PROPOSED GARAGE CONVERSION TO 'PLAY ROOM'

AND CONSERVATORY AT

DRG NO 05/11/MS
DRAWN BJD SANDERS (238060483)

SECTION B-B

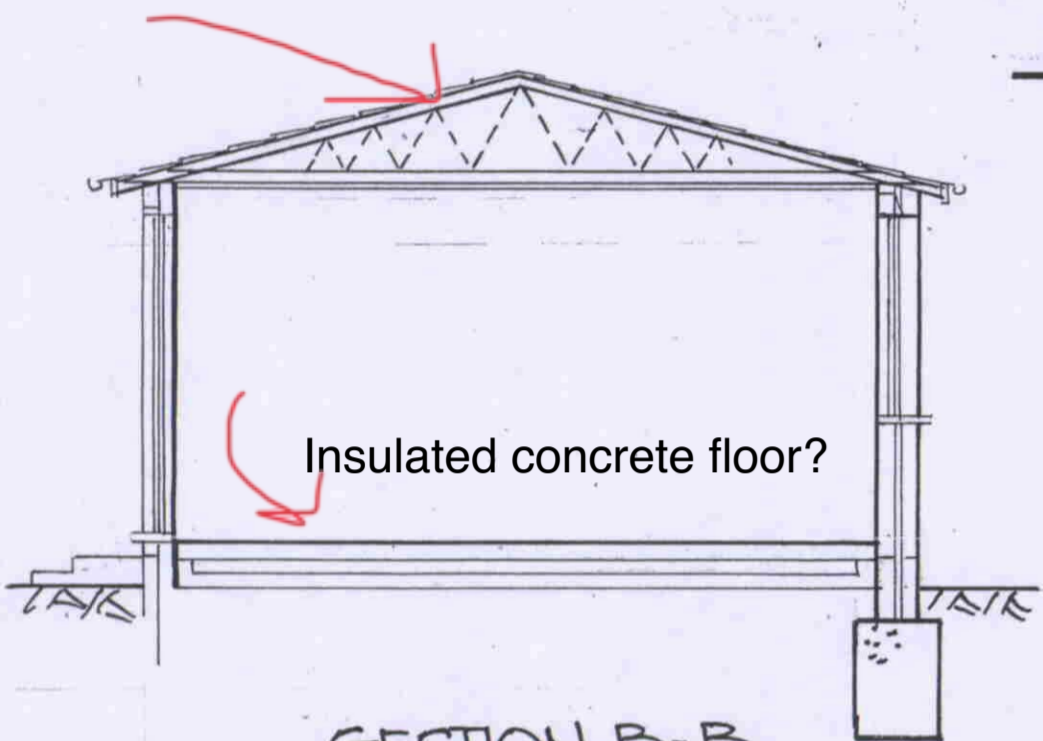
Surely the roof supports aren't like this?

SECTION A-A
1:25

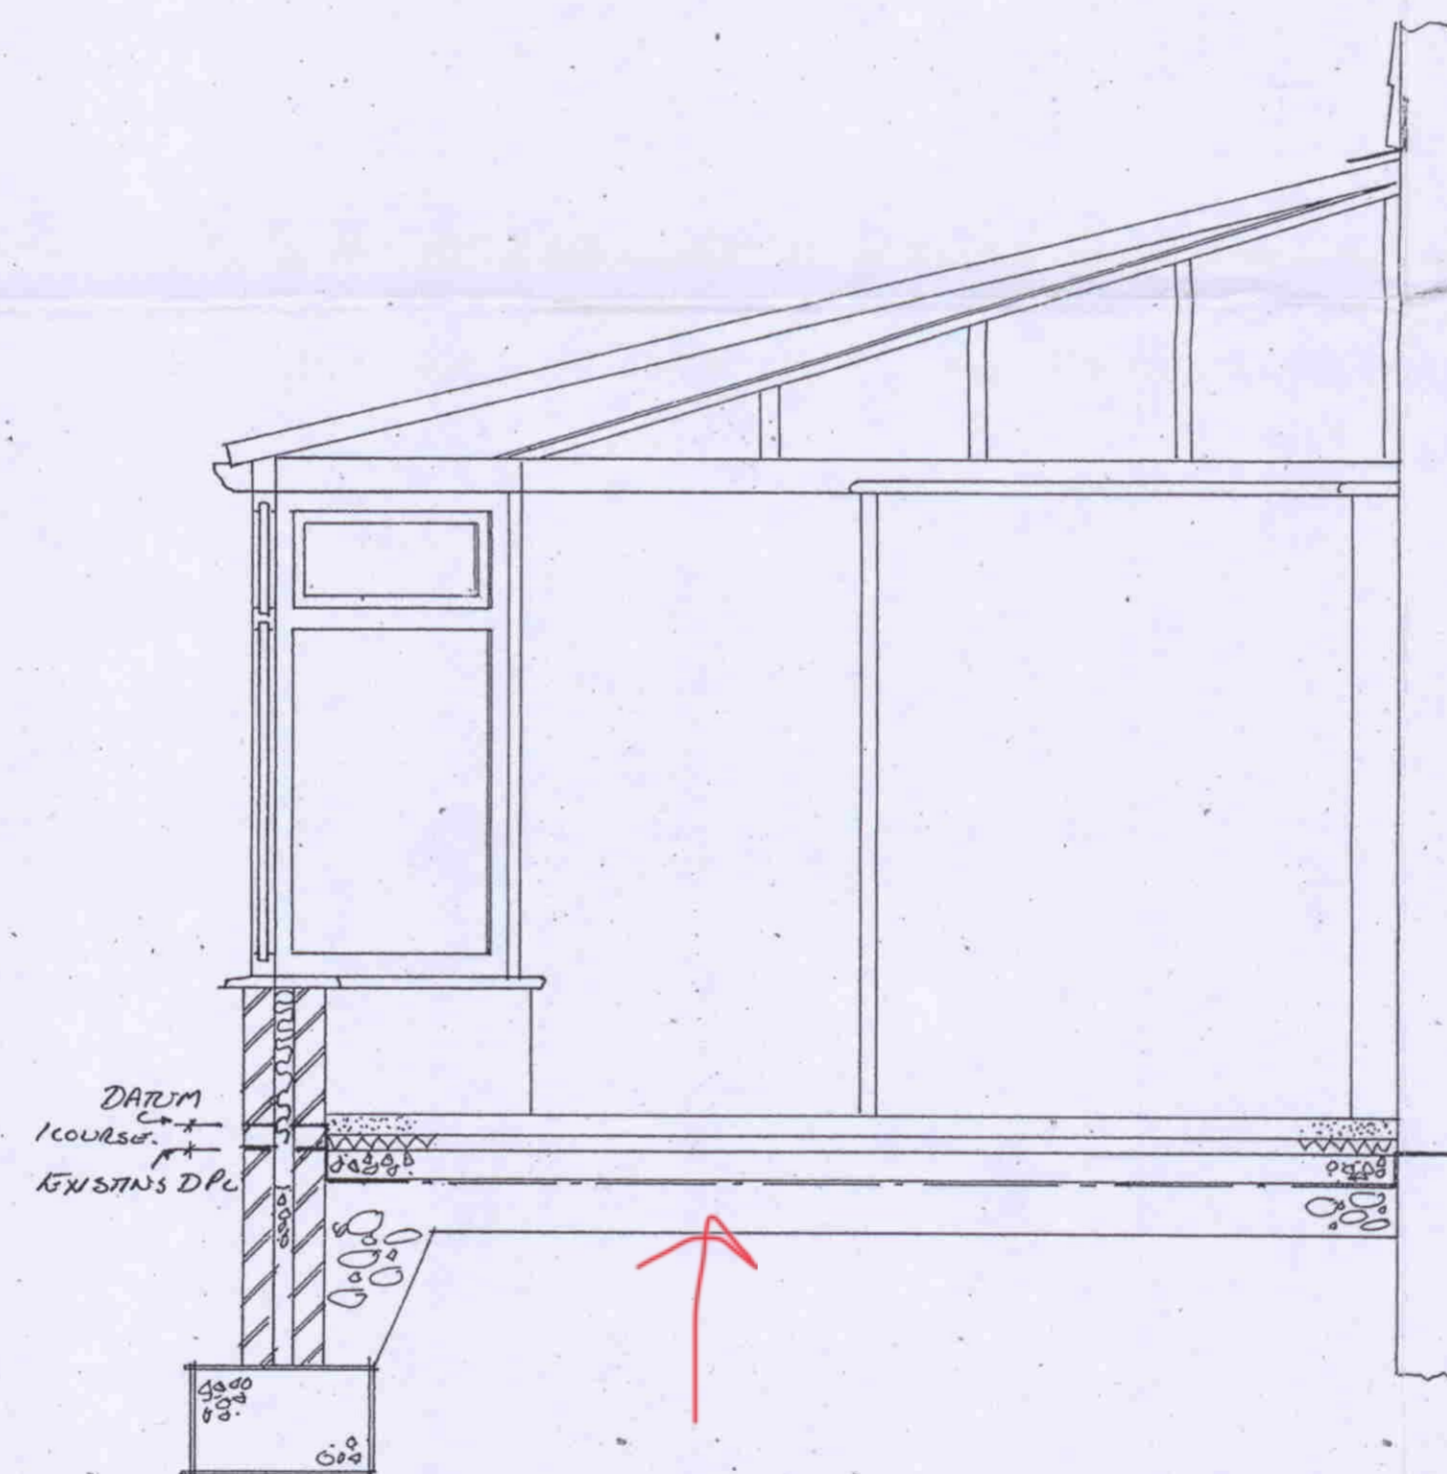
Single skin brick wall? Just dot and dab non-insulated plasterboard?

Insulated concrete floor?
